Addendum 3

Client: Creswell School District
Project: CHS Academic Building Improvements (Primary) Project
Date: March 11, 2026
To: Interested Bidder
Prepared by: Curt Wilson, AIA; Principal, Wilson Architecture

This Addendum modifies the Project Manual, Specifications, and Drawings as follows:

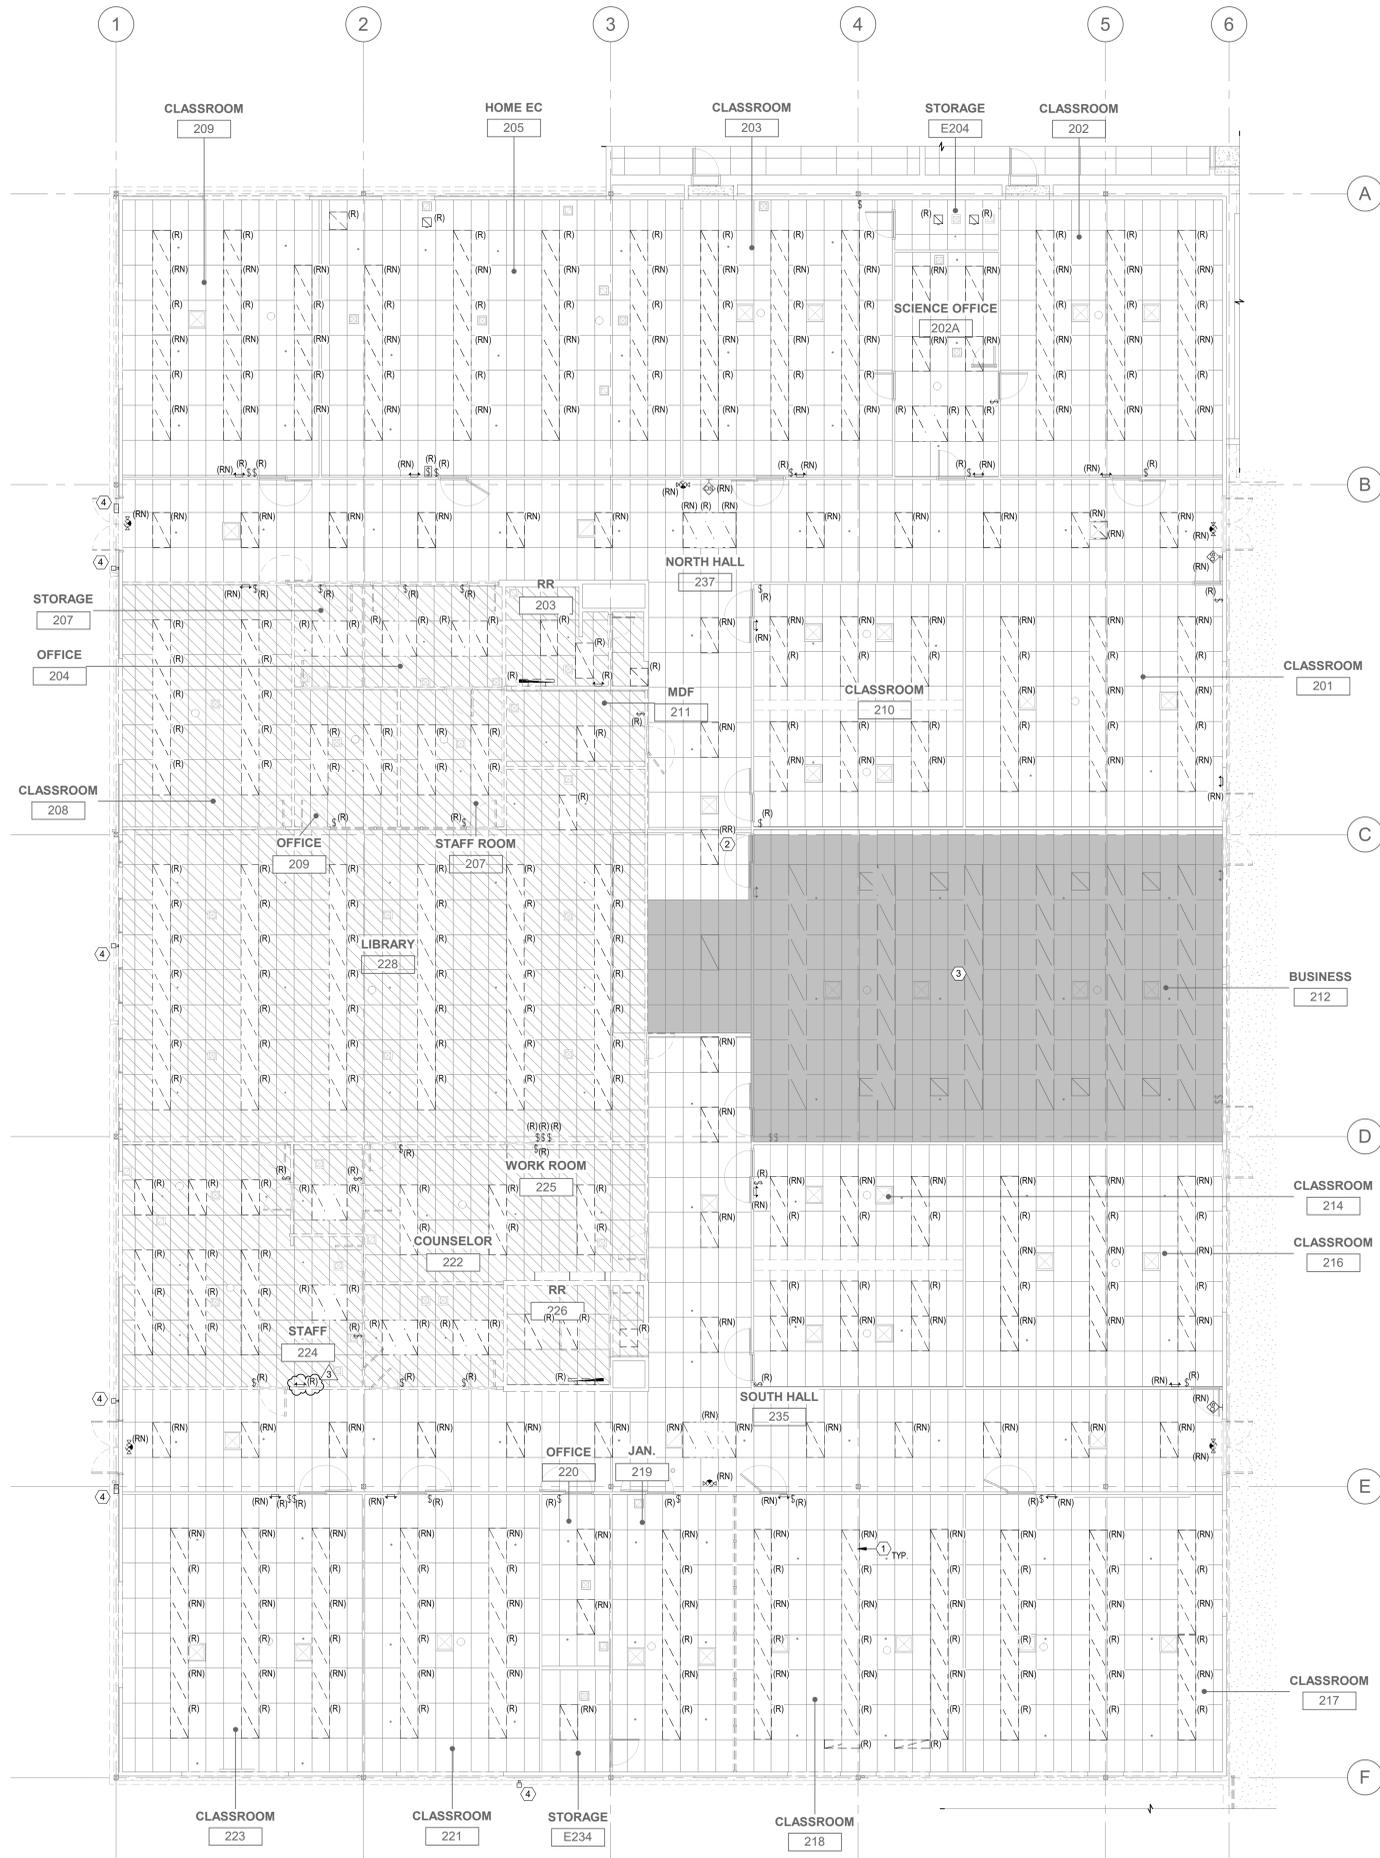
- 3.17. Sheet ED2.11 - Demo Rcp - Area B - Electrical
- a. Replace original sheet with attached version. A brief summary of the changes include:

- Changed phase tag to remove, for egress bug eye fixture in Staff 224.

1 FLOOR PLAN AREA A - ELECTRICAL
E1.10 1/8" = 1'-0"

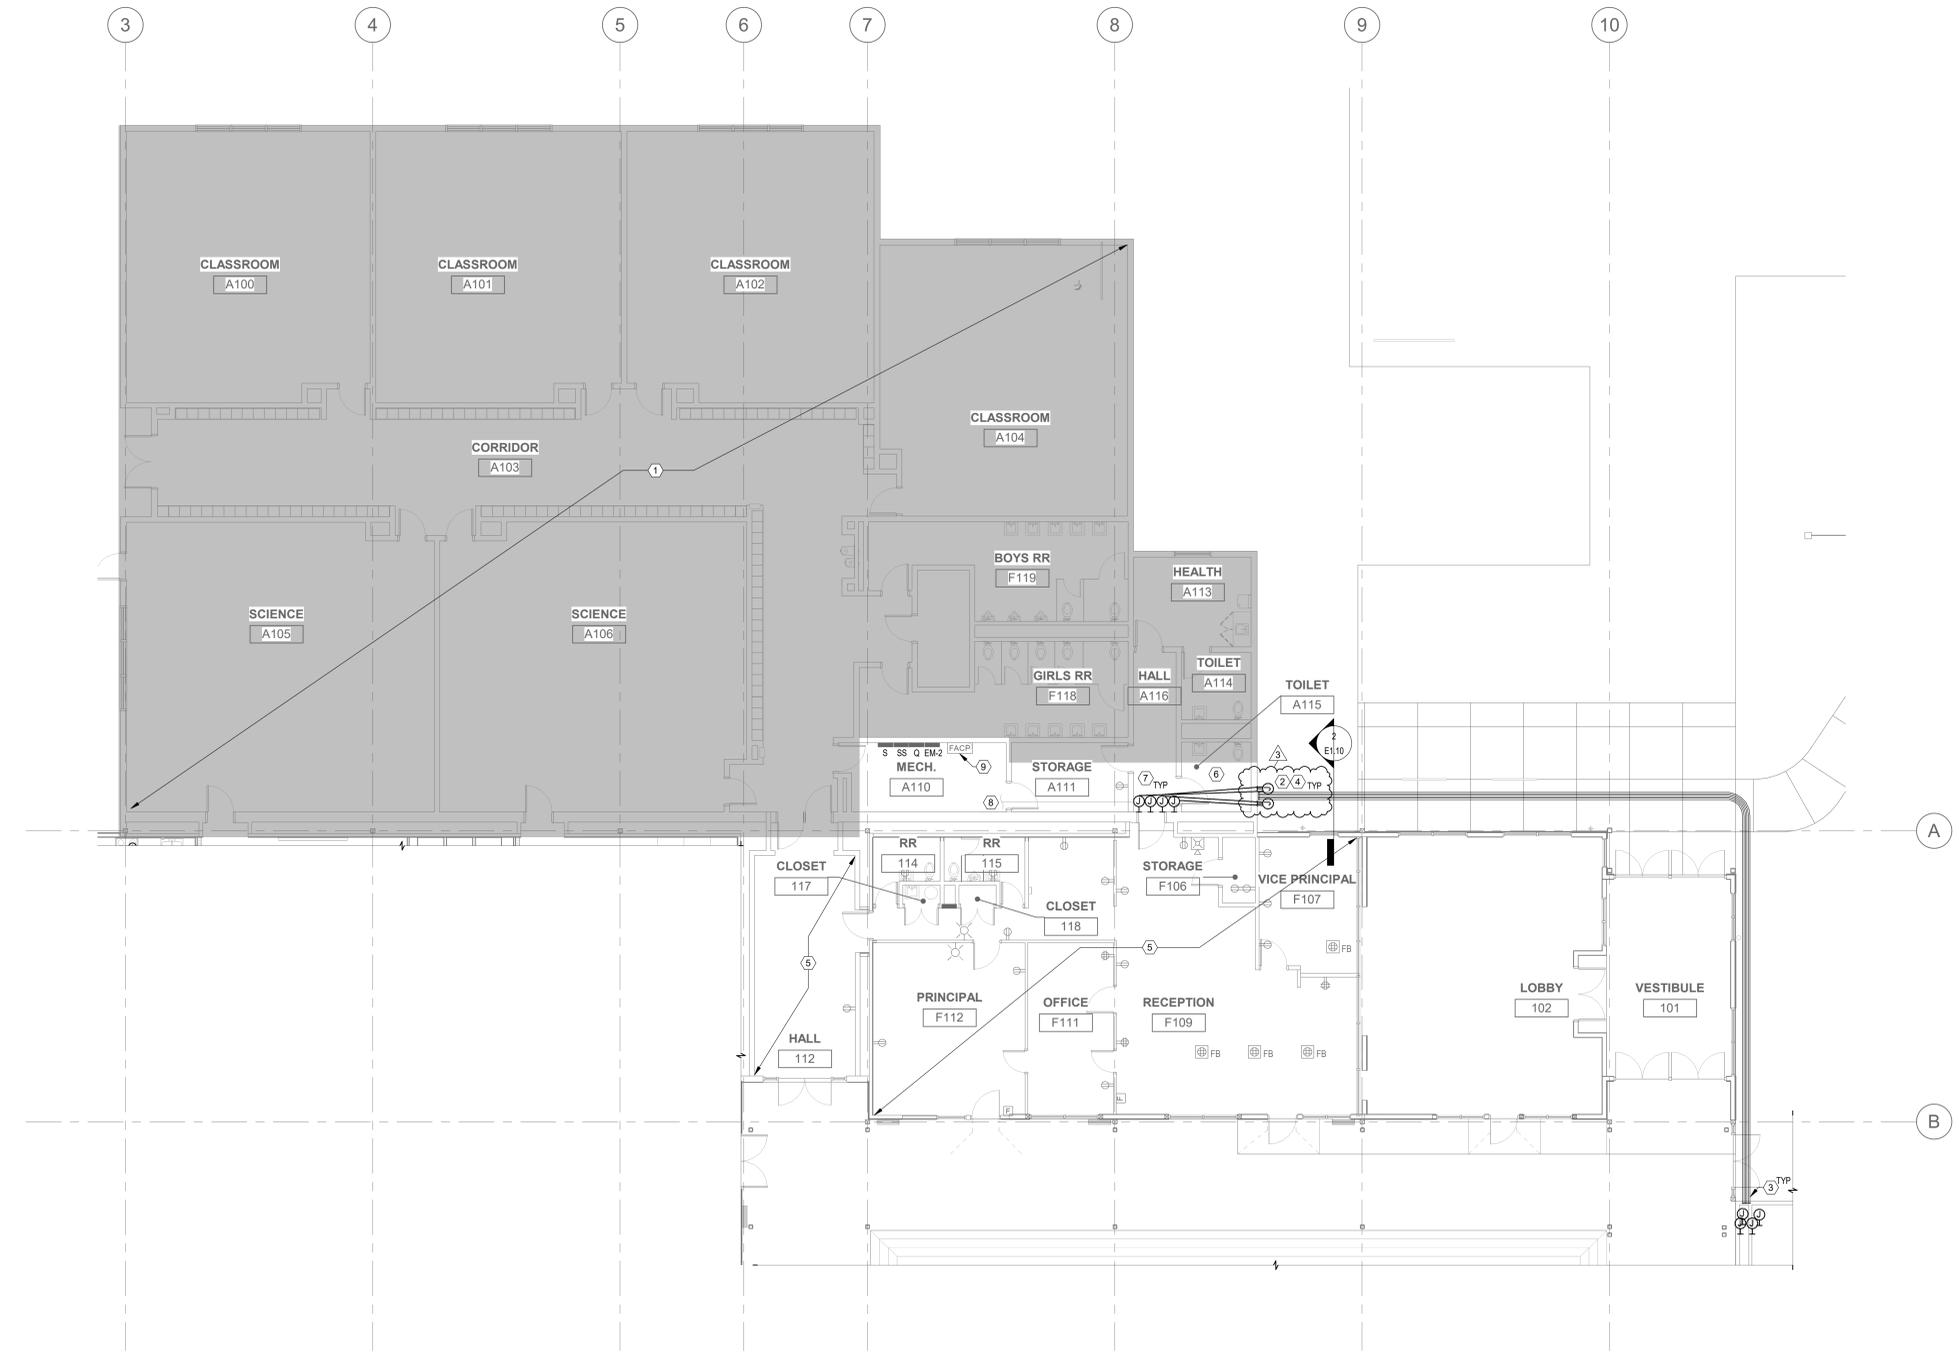
3.18. Sheet E1.10 - Floor Plan - Area A - Electrical

- a. Replace original sheet with attached version. A brief summary of the changes include:
- Revised exterior wall mounted junction box layout and requirements
 - Updated keynote #2.

1 FLOOR PLAN AREA B - PLBG ABOVE GROUND
 P1.13 1/8" = 1'-0"

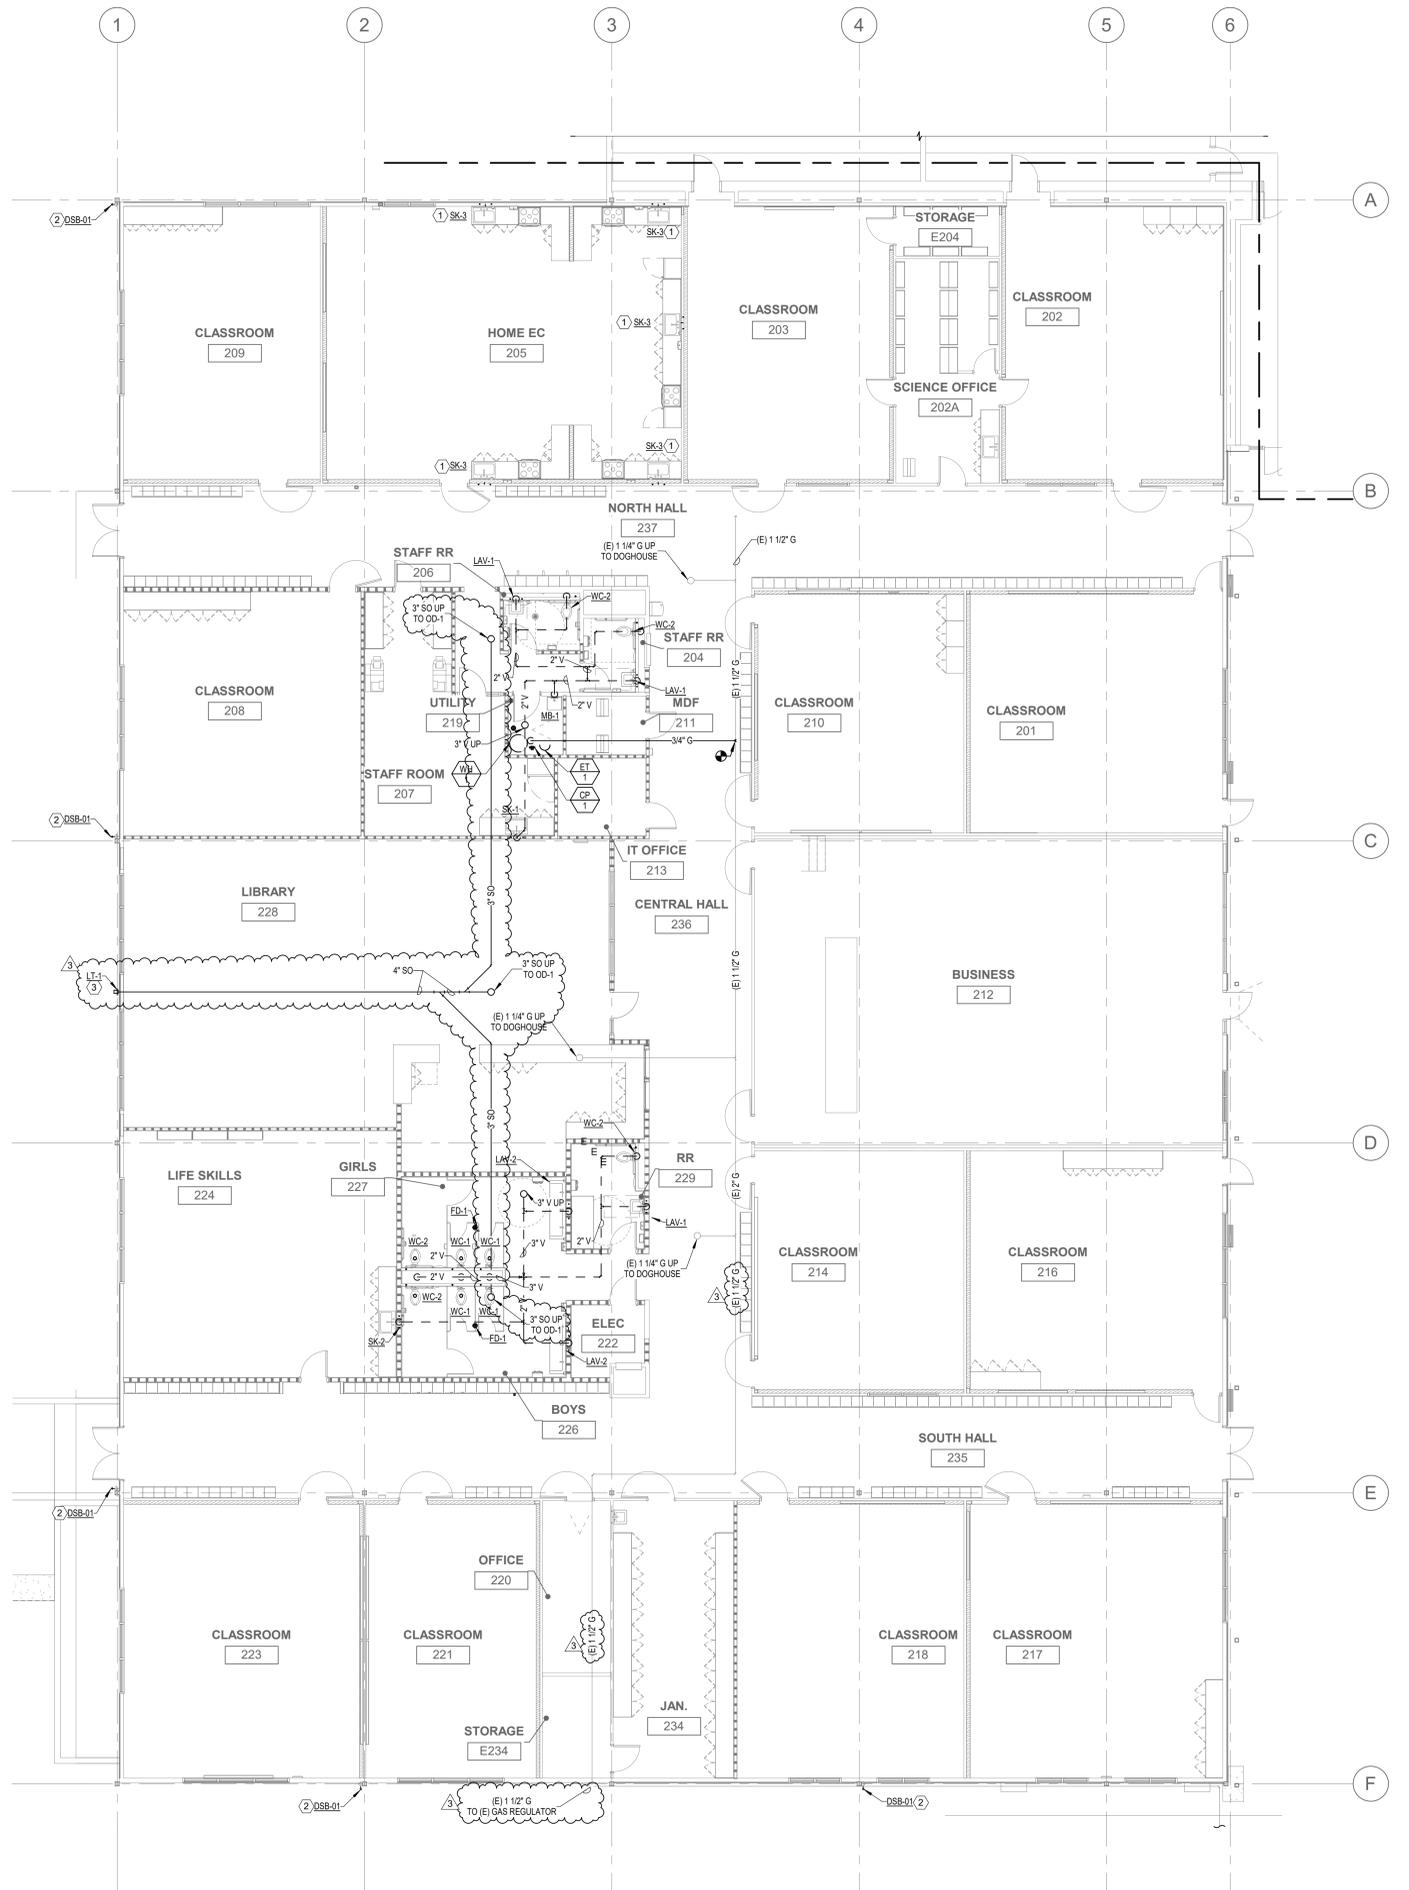
3.21. Sheet P1.13 – Floor Plan Area B Plumbing Above

- a. Replace original sheet with attached version. A brief summary of the changes include:
- New overflow storm piping routed to new lambs tongue downspout nozzle.

1 ROOF PLAN AREA B - PLBG
P1.22 1/8" = 1'-0"

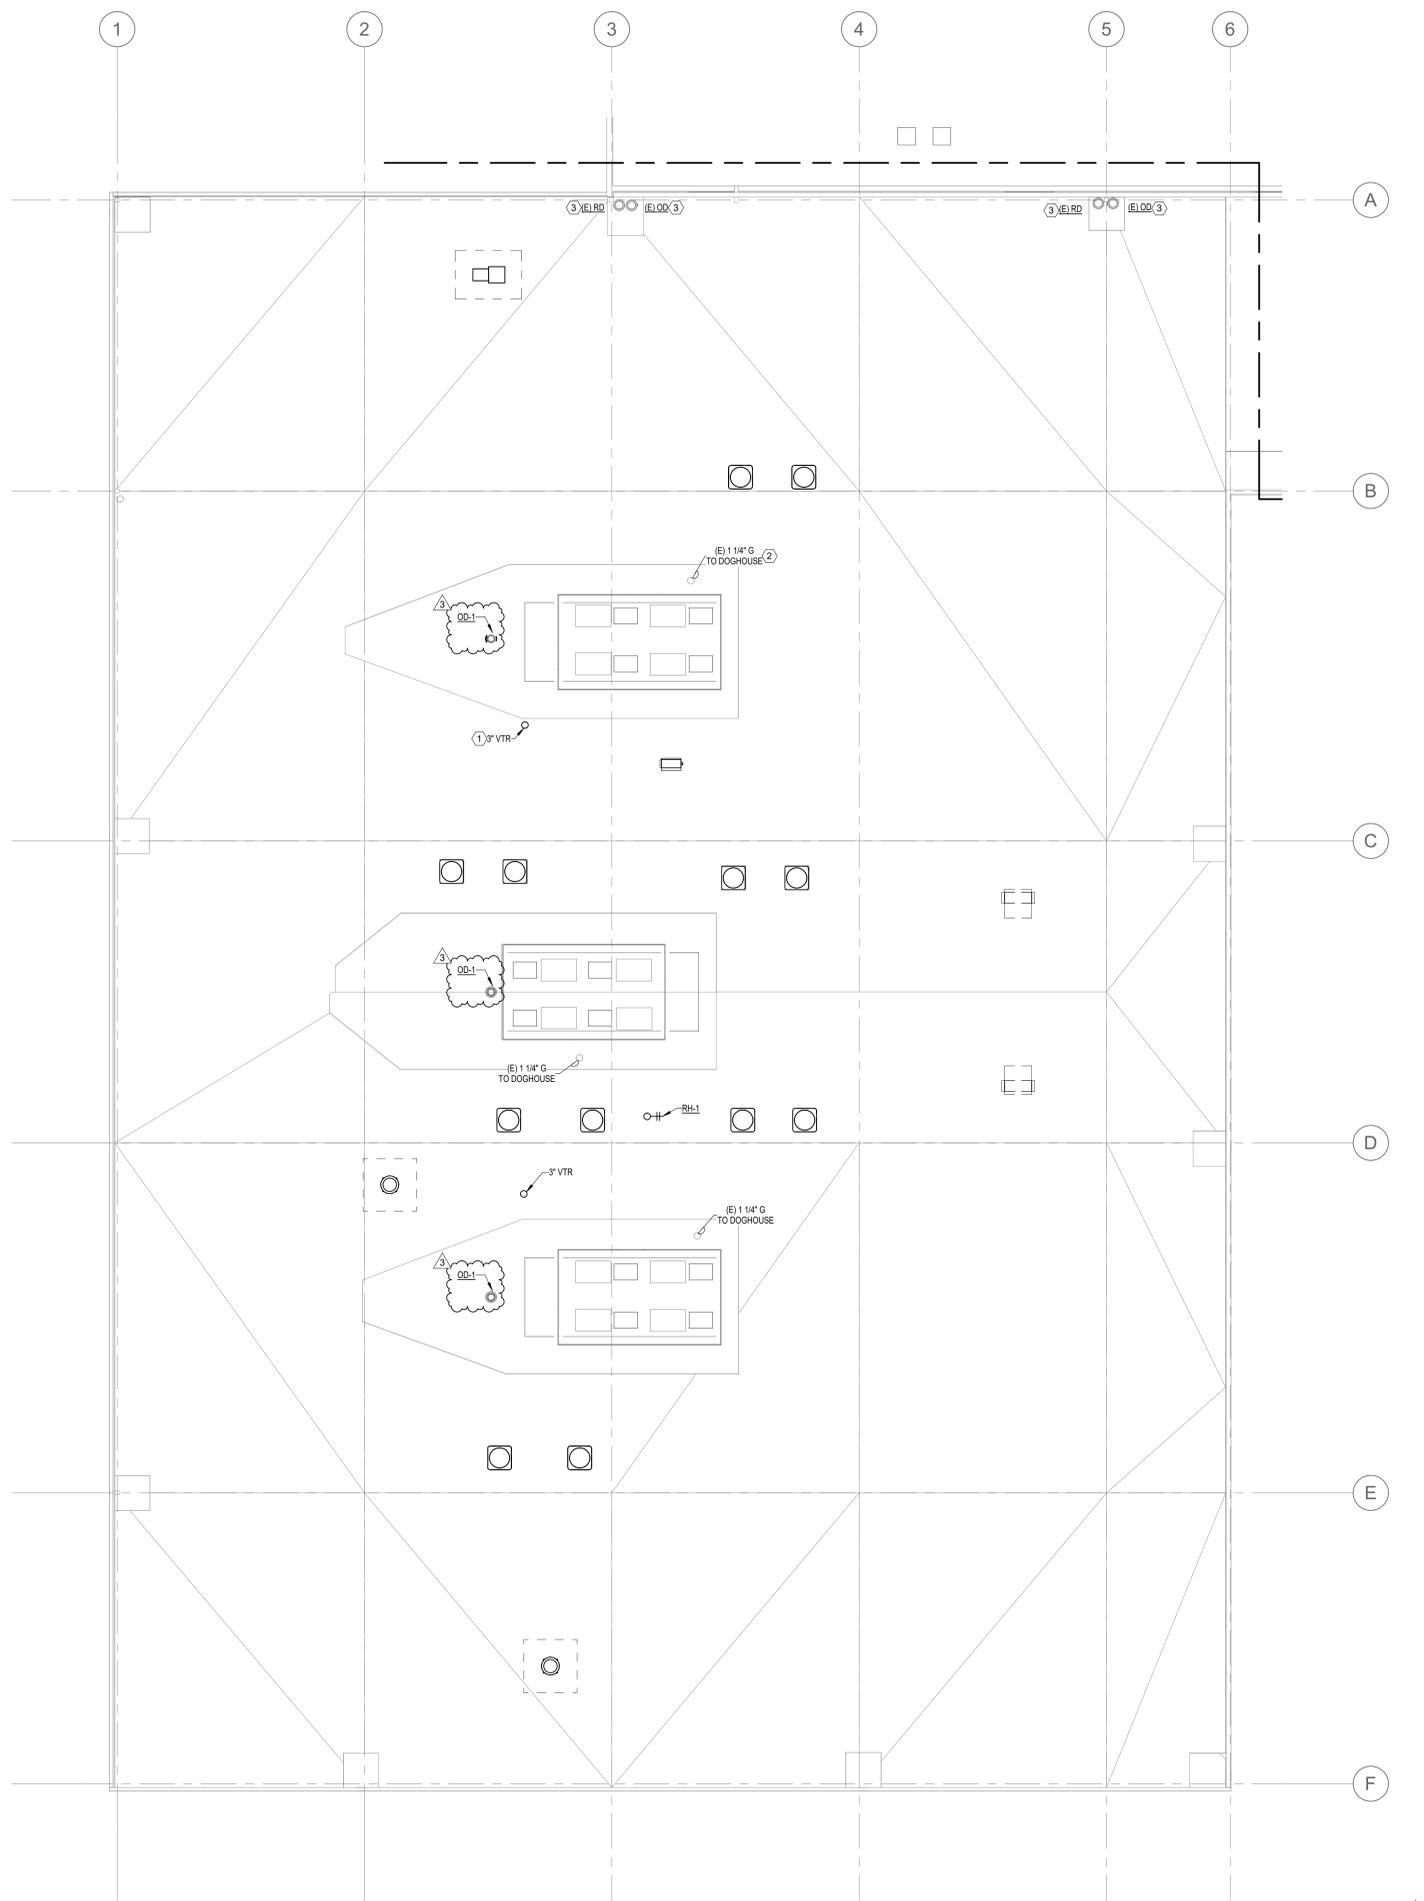
3.22. Sheet P1.22 - Roof Plan - Area B - Plumbing

- a. Replace original sheet with attached version. A brief summary of the changes include:
- New overflow drains were added.
